Technical Service Bulletin

SUBJECT:			No:	TSB-19-52A-003
CORRECTION TO FRONT PILLAR TRIM			DATE:	August 2019
ASSEMBLY INSTALLATION PROCEDURE - SMR				2015-19 Outlander Sport/RVR
CIRCULATE TO:	[] GENERAL MANAGER	[] PARTS MANAGER		[X] TECHNICIAN
[X] SERVICE ADVISOR	[X] SERVICE MANAGER	[X] WARRANTY PROCESSOR		[] SALES MANAGER

This TSB updates the Interior and Supplemental Restraint System (SRS) section of the affected Service Manuals, to correct the front pillar trim assembly installation procedure.

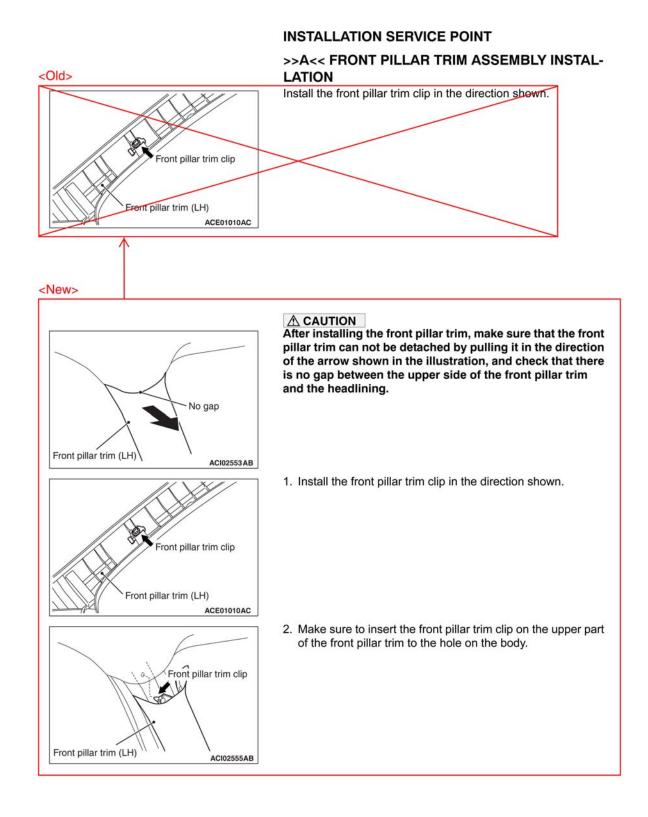
Please make the indicated changes to the 2015 Outlander Sport/RVR Service Manual, Group 52-Interior and Supplemental Restraint System (SRS) -> Group 52A-Interior -> Trims -> Interior Trim Removal and Installation.

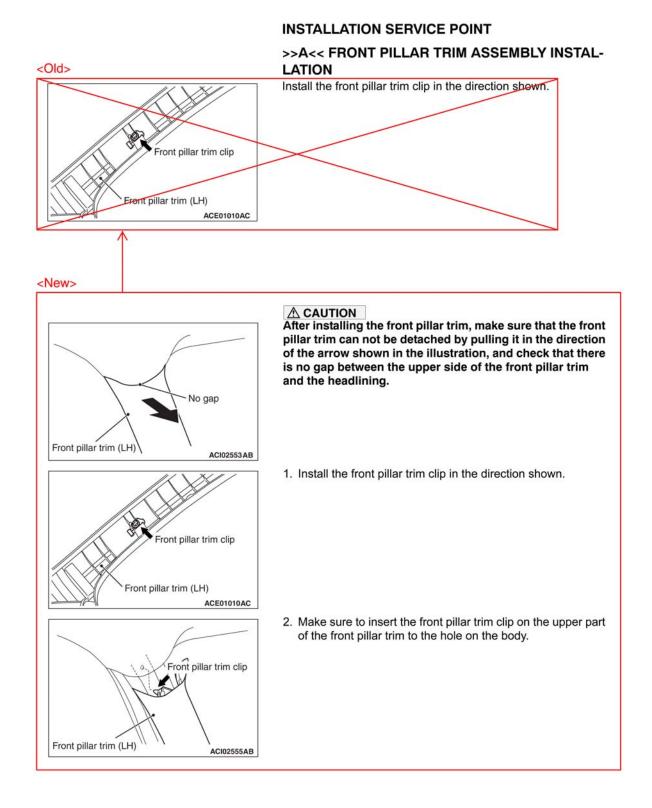
Please make the indicated changes to the 2016 Outlander Sport/RVR Service Manual, Group 52-Interior and Supplemental Restraint System (SRS) -> Group 52A-Interior -> Trims -> Interior Trim Removal and Installation.
